# MAGNOLIA MIXED USE

DPD Project #3035295-LU

Recommendation Meeting  
West Design Review Board

STREET FRONTAGE - 32ND AVE W (EDG CONCEPT 3)

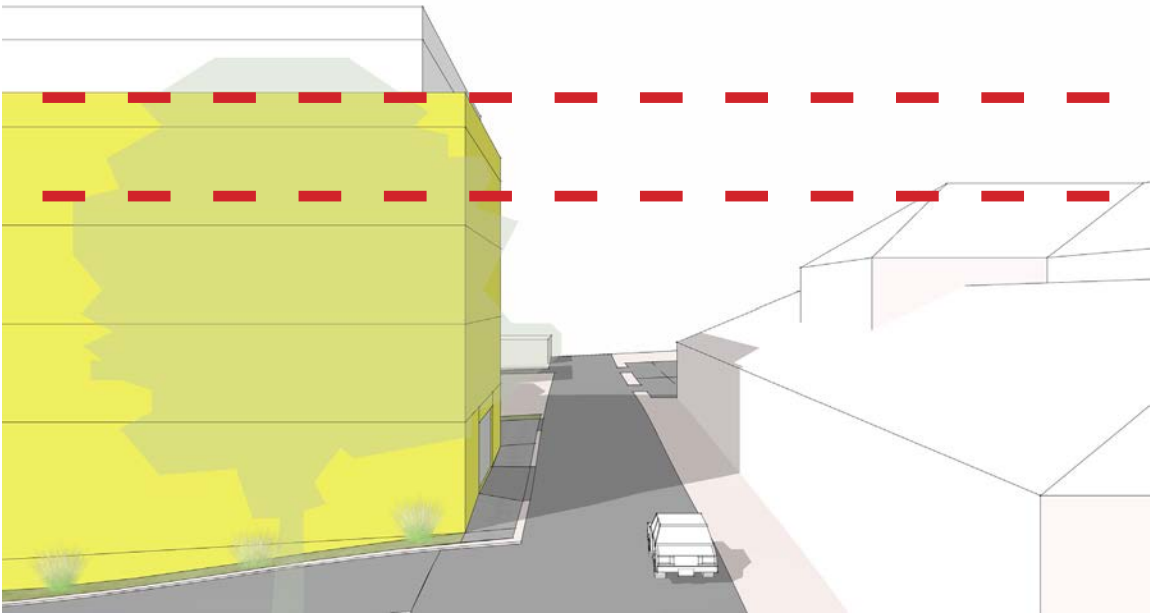
- a. The Board preferred Design Concept 3 over the other two design options due to its stronger concept legibility over the other two options, its greater ability to transition to the shorter contextual building height through its lower projecting mass, and the provision of a legible residential entry setback along the street (DC2-A-2. Reducing Perceived Mass, DC2-B. Architectural and Façade Composition, DC2-C-3. Fit With Neighboring Buildings).
- b. The Board gave guidance to strengthen the legibility of the massing concept and better relating to surrounding contextual height, including the zone transition to the east, by reducing the height of the projecting yellow mass shown in the packet by one floor along all facades (CS2-A-2. Architectural Presence, CS2-D. Height, Bulk, Scale, DC2-A. Massing, DC2-D-1. Human Scale).

Per the Board’s recommendation the lower mass has been lowered a level to better relate to the surrounding context and zoning transition across the alley.

STREET FRONTAGE - 32ND AVE W (PRIOR CONCEPT 3)

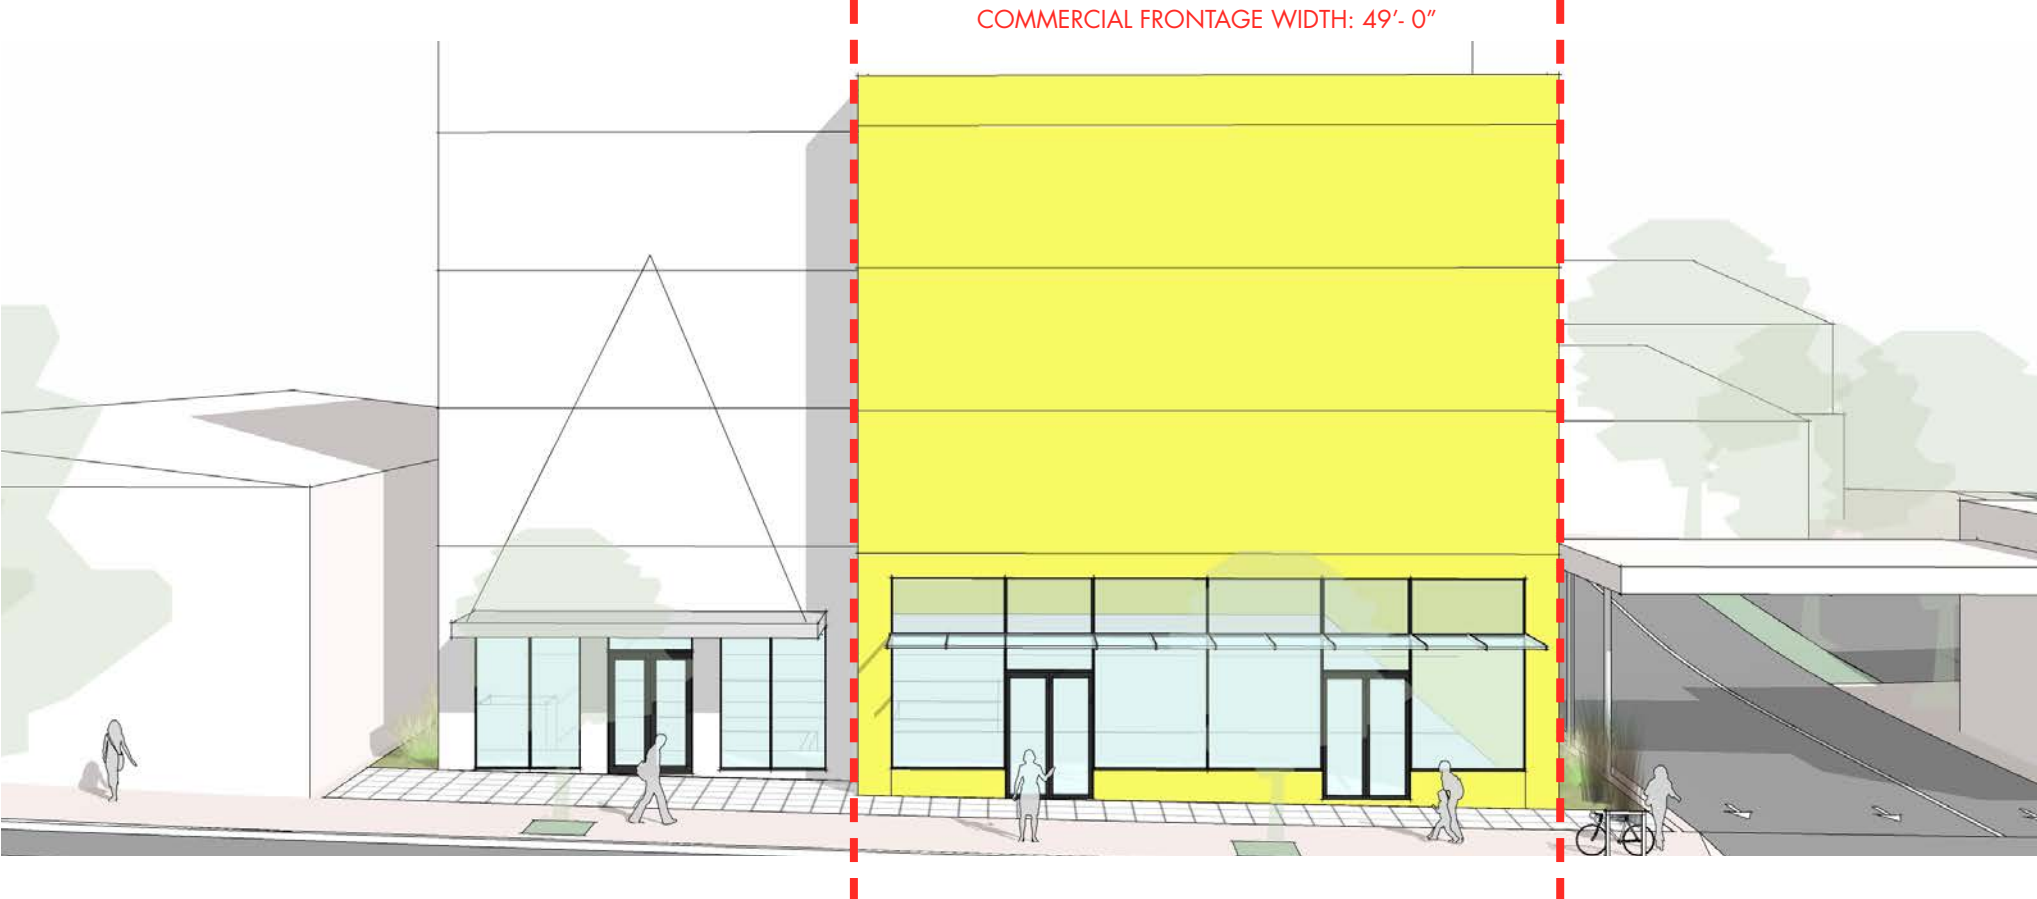
a. The Board acknowledged public comment that emphasized the need for an active street frontage and requested additional emphasis of the commercial frontage along the street frontage through the increase of commercial street frontage and reduction of the residential lobby width. The Board requested additional study at the Recommendation phase to examine increasing the length of commercial space along the street frontage both with and without widening the projecting commercial massing element (CS2-B-2. Connection to the Street, PL1-B-3. Pedestrian Amenities, PL2-B-3. Street-Level Transparency, PL2-D. Wayfinding, PL3-A. Entries, PL3-C-2. Visibility, DC1-A. Arrangement of Interior Uses).

After reviewing options for the street frontage commercial component, the design was revised to increase the length of the commercial area along the street front as well as the massing that it is part of. In reviewing the massing, it makes sense to have the lower mass contain all of the commercial space at the ground level in order to be true to the form of the building. The recessed residential massing has been reduced, but still provides ample space for the entrance and plaza alike.

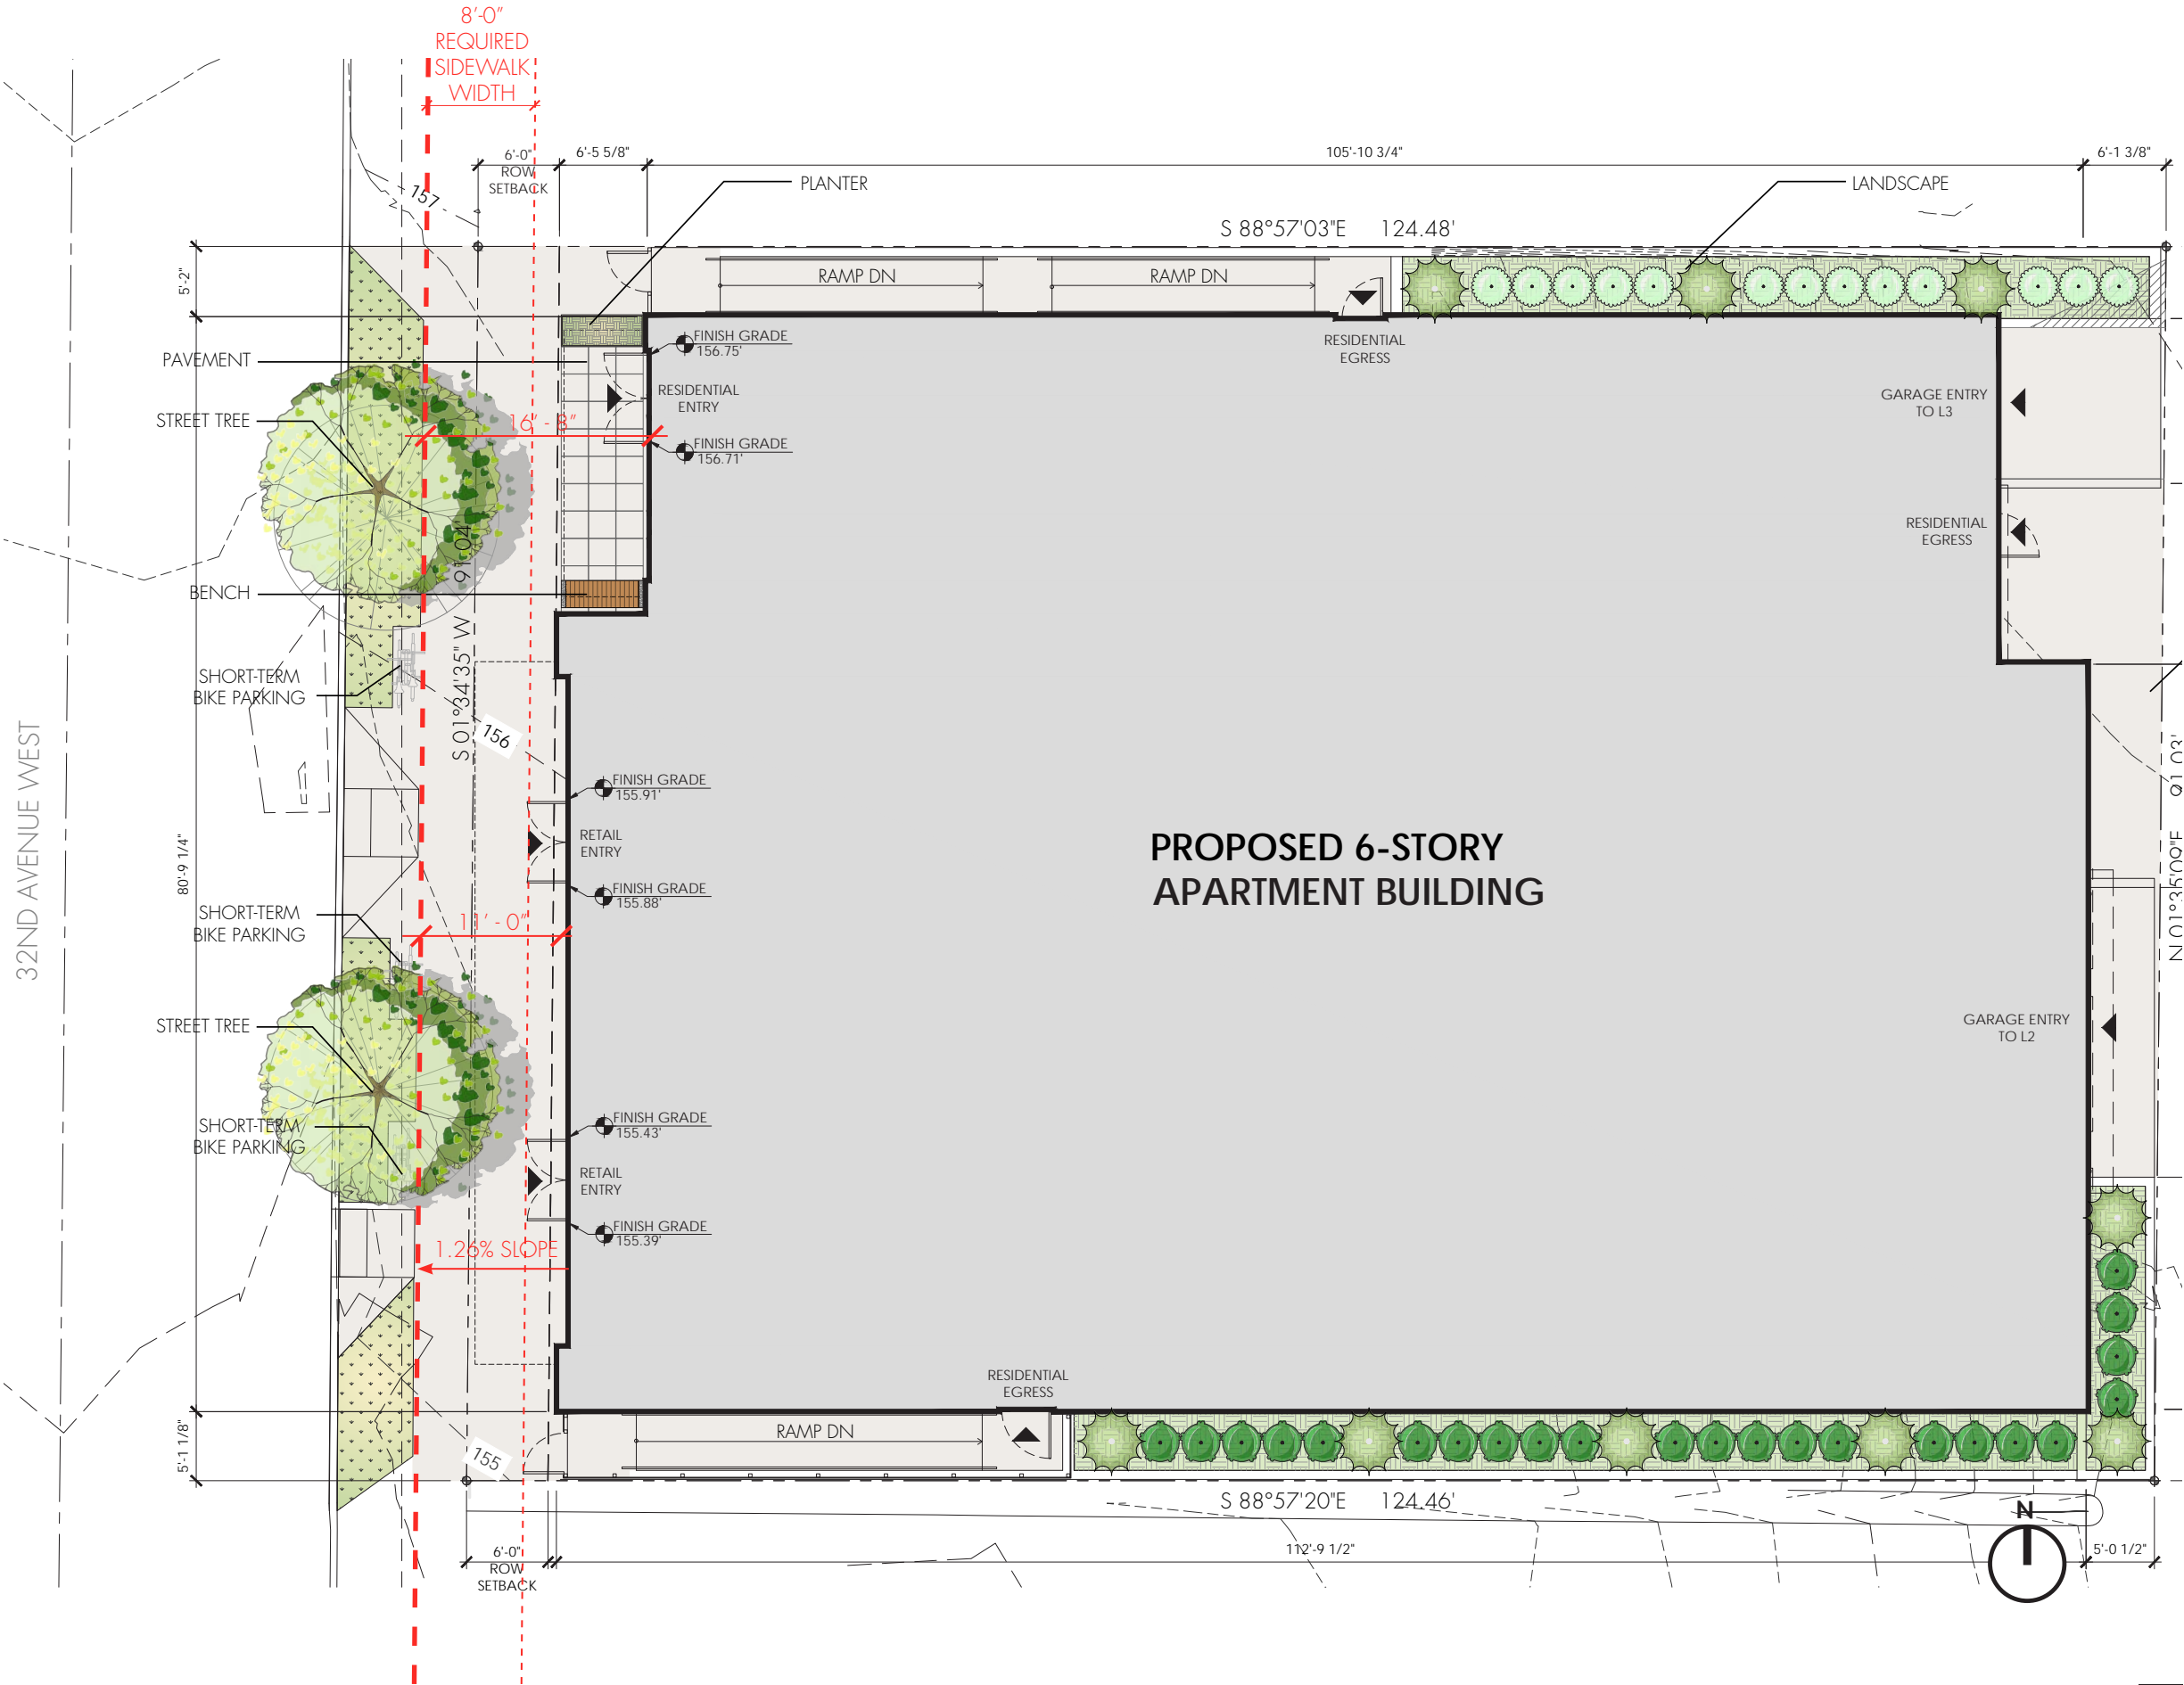
b. The Board echoed the sidewalk width recommendations of SDOT for a minimum 8-foot sidewalk width. The Board added that the expression of the concept and legibility of modulation shifts should not be compromised in achieving this additional sidewalk width (PL1-B. Walkways and Connections, PL4-A-2. connections to All Modes).

Per the Board’s and SDOT’s recommendations the sidewalk has been enlarged to be at least 8 feet in all locations with an additional recess at the residential entrance plaza.

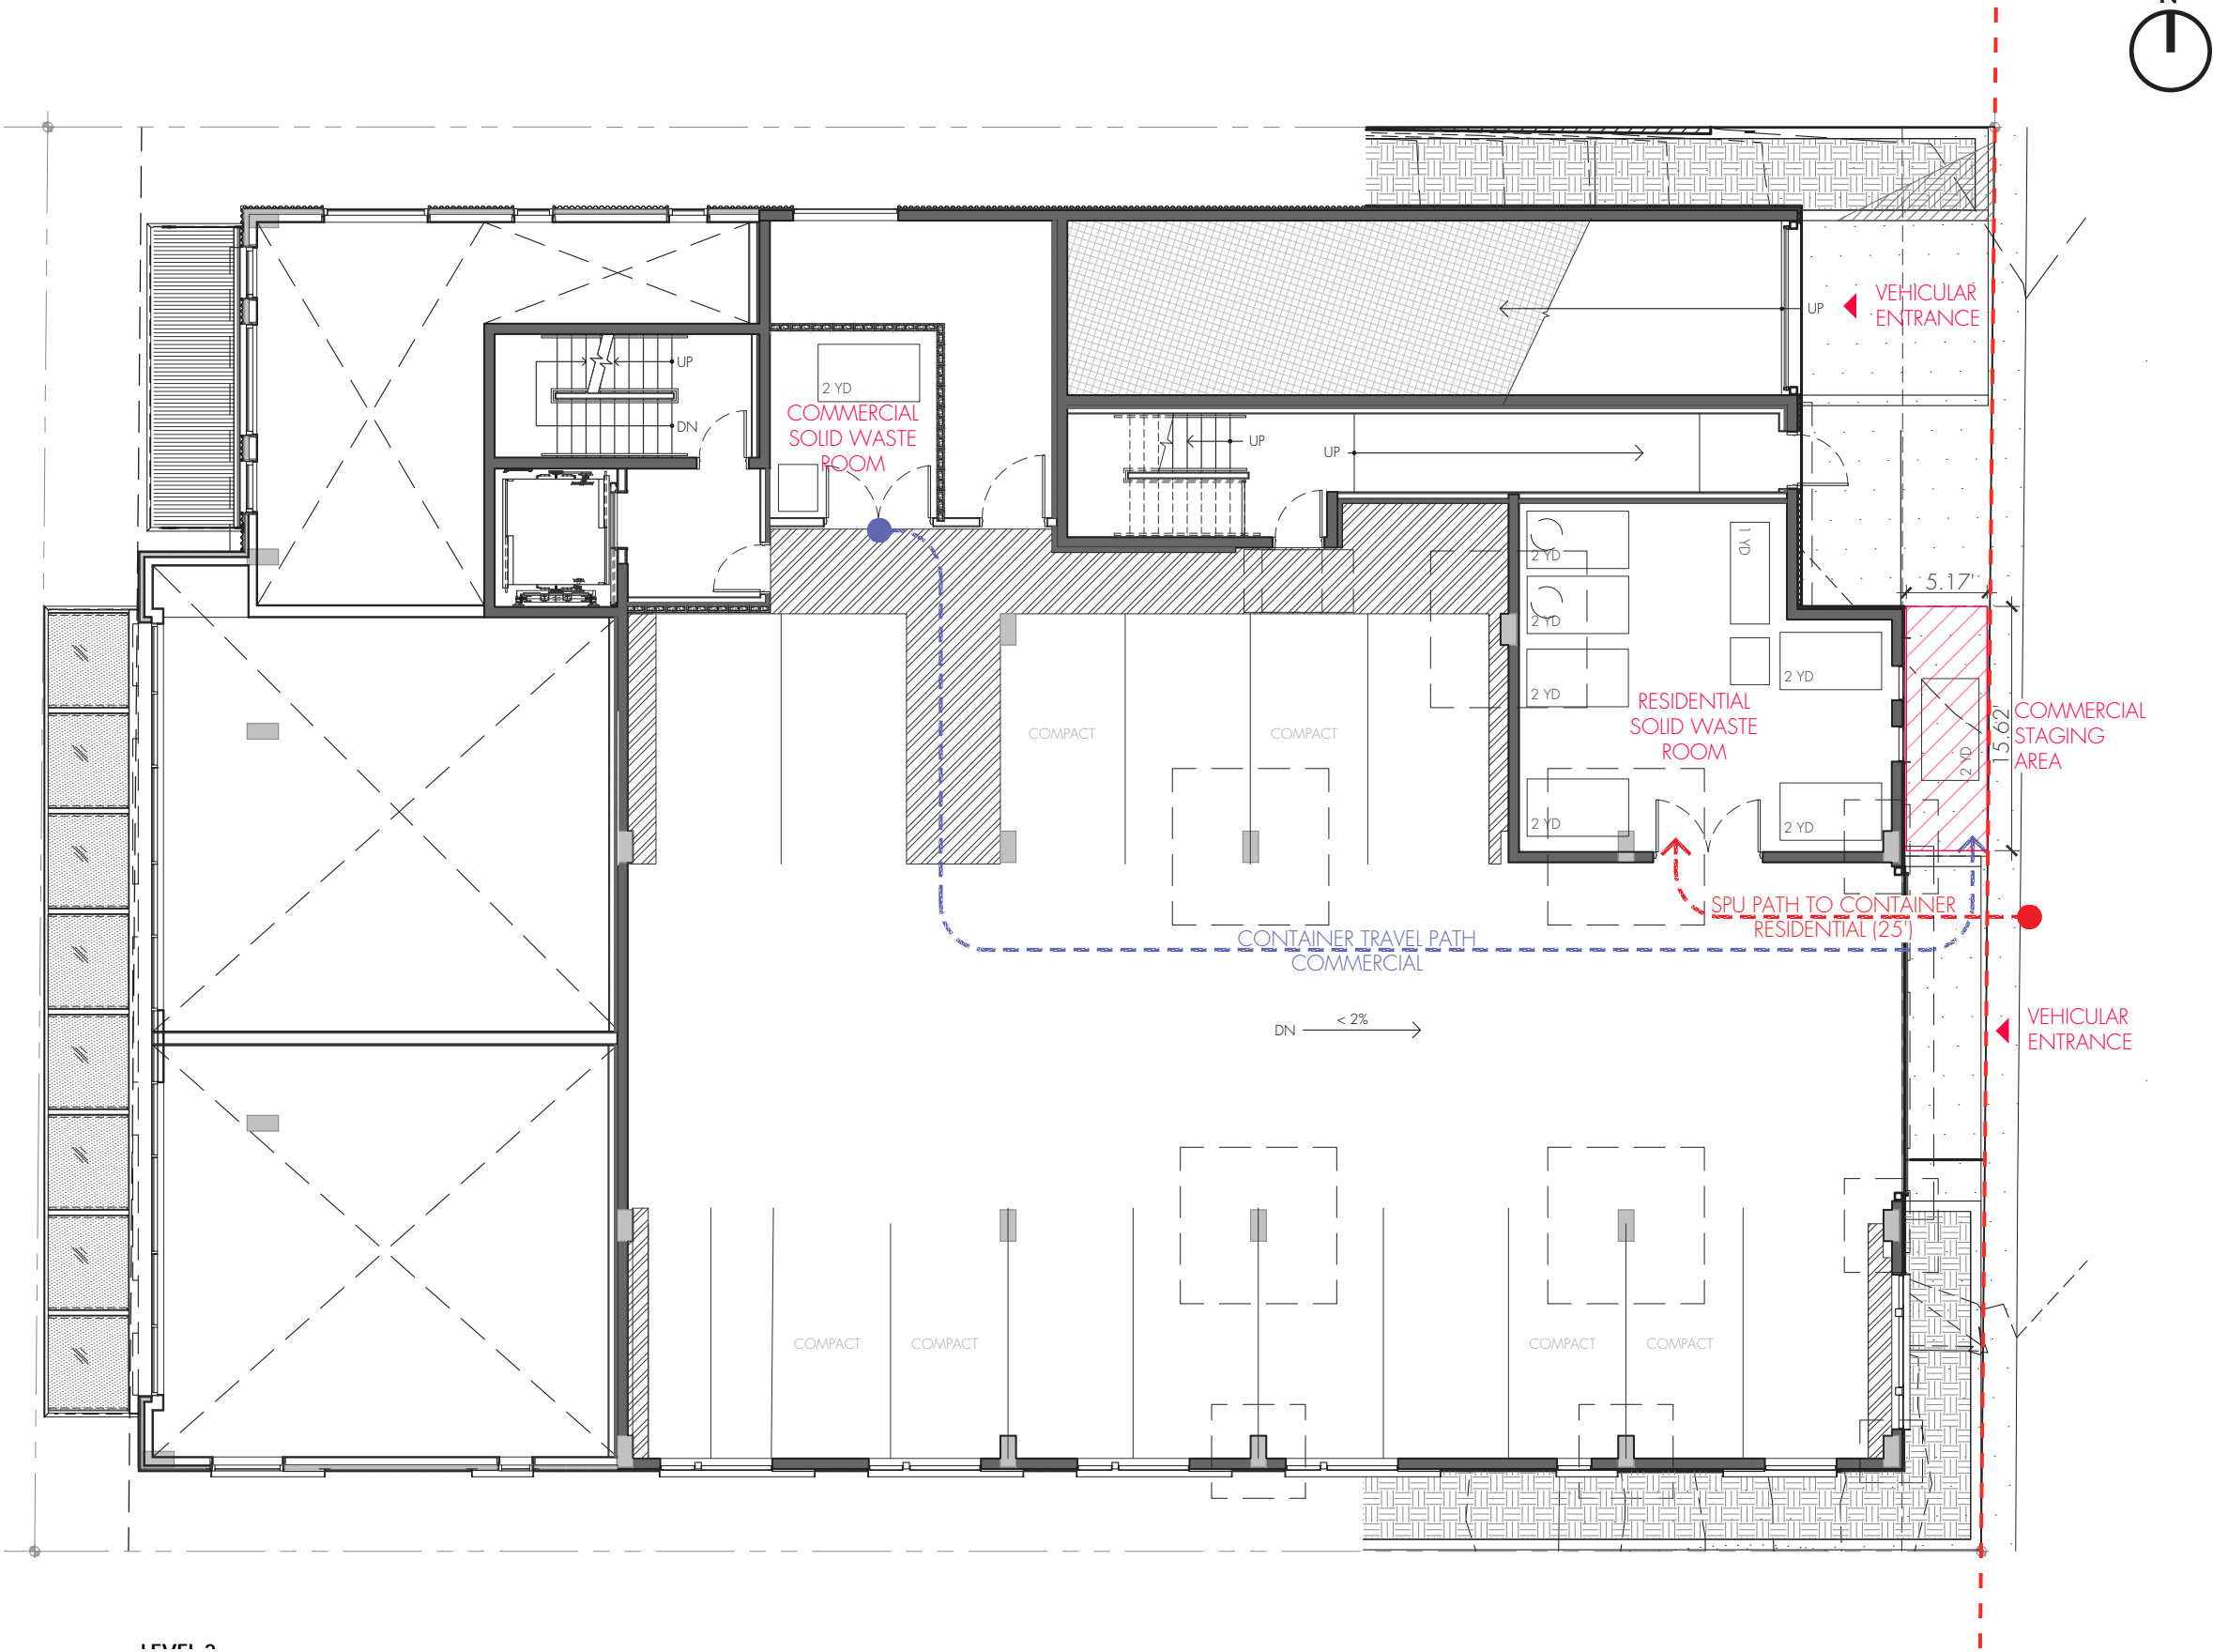
c. The Board expressed concern that extraneous vehicle movements in the alley, caused by the three separate access points to parking and solid waste collection, may interrupt pedestrian movements. The Board requested additional study, to be shown at the Recommendation phase of review, that examines the reduction of vehicle access points. Specifically, the Board requested study of a parking and solid waste organization that consolidates parking and solid waste collection access to one location. The Board requested a separate study showing two total access points: one for vehicle parking and another for solid waste access (DC1-B-1. Access Location and Design, DC1-C. Parking and Service Uses).

After review of the site conditions and limitations the design has been revised to only have two access points, one for each level for the vehicular entrances/exits. We have obtained approval from SPU on the solid waste collection as proposed in the plans, which allows us to remove the originally proposed doorway. The site is too small to just have one vehicular access into the building to be able to get the required parking for the proposed unit counts, which is why there are two locations for this along the alley.

MATERIAL SAMPLE IMAGE

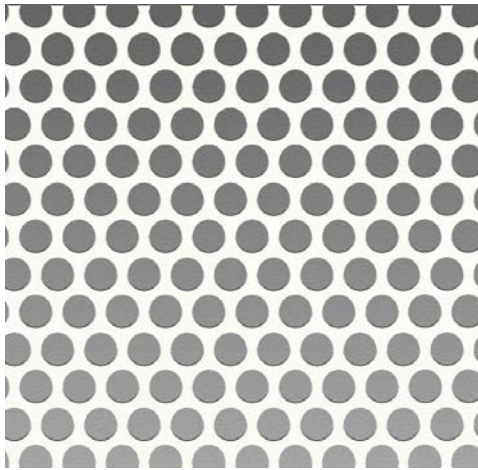
a. The Board emphasized the need for high-quality materials including masonry, and discouraged the use of fiber cement panels as an exterior material. The Board encouraged the examination of the surrounding commercial context for examples of materials that are responsive to context (DC4-A-1 Exterior Finish Materials).

High quality materials are proposed for the project including brick and metal siding. See pages 24-28 for the specific materials proposed for the project.
